Project	<b>IEEE 802.16 Broadband Wireless Access Working Group</b> < <a href="http://ieee802.org/16">http://ieee802.org/16</a> >	
Title	<b>Correct Figure for TEK management in BS and MS</b>	
Date Submitted	<b>2005-07-15</b>	
	Sangwoo Doe, Sungsoo Oh, SungHo Yoo POSDATA Co. Ltd.	doeing@posdata.co.kr
Re:	Response to Sponsor Ballot on IEEE802.16e/D9 document	
Abstract	<b>Correct Figure for TEK management in BS and MS</b>	
Purpose	To incorporate the figure changes proposed in this contribution into the 802.16e/D9 draft	
Notice	This document has been prepared to assist IEEE 802.16. It is offered as a basis for discussion and is not binding on the contributing individual(s) or organization(s). The material in this document is subject to change in form and content after further study. The contributor(s) reserve(s) the right to add, amend or withdraw material contained herein.	
Release	The contributor grants a free, irrevocable license to the IEEE to incorporate material contained in this contribution, and any modifications thereof, in the creation of an IEEE Standards publication; to copyright in the IEEE's name any IEEE Standards publication even though it may include portions of this co

Figure 134 -TEK management in BS and SS

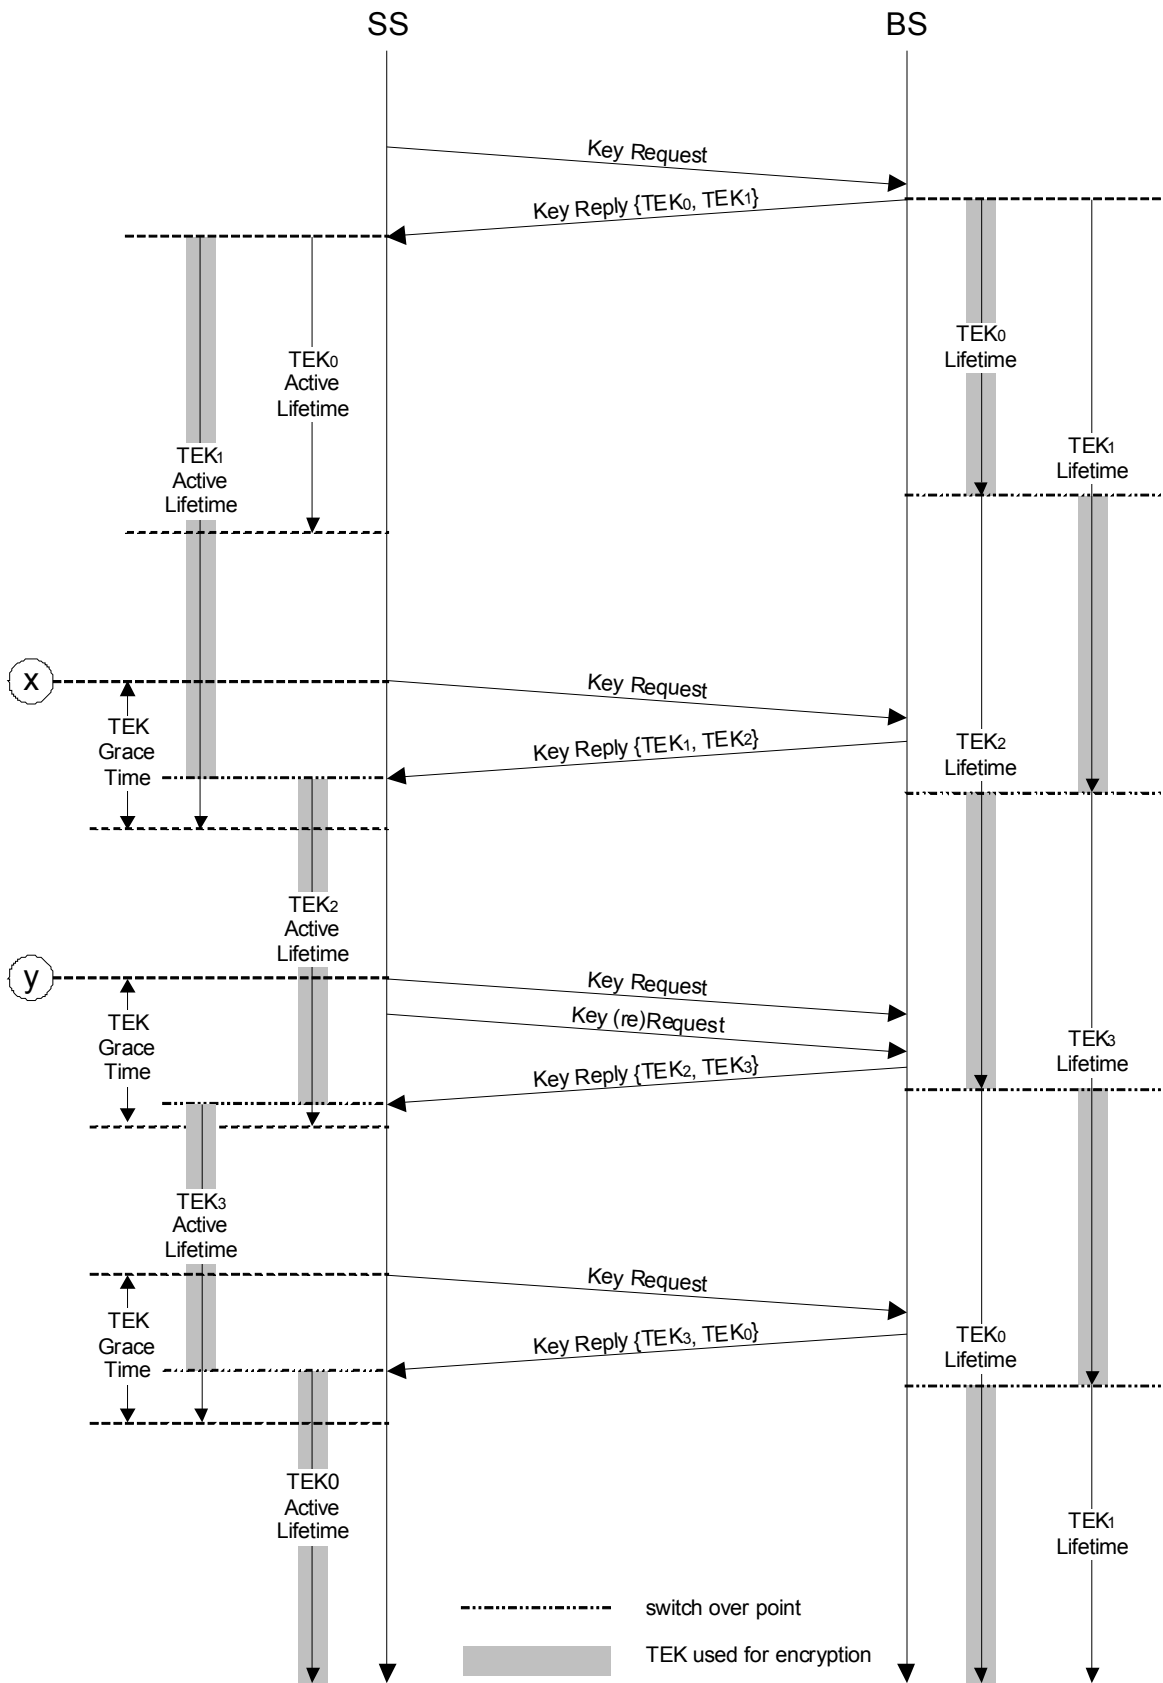
“Through operation of its TEK state machines, an SS shall request a new set of traffic keying material a configurable amount of time, the *TEK Grace Time* [see points (x) and (y) in Figure 134], before the MS's latest TEK is scheduled to expire.” However, Figure 134 is incorrect.

We suggest a correct figure as follows.
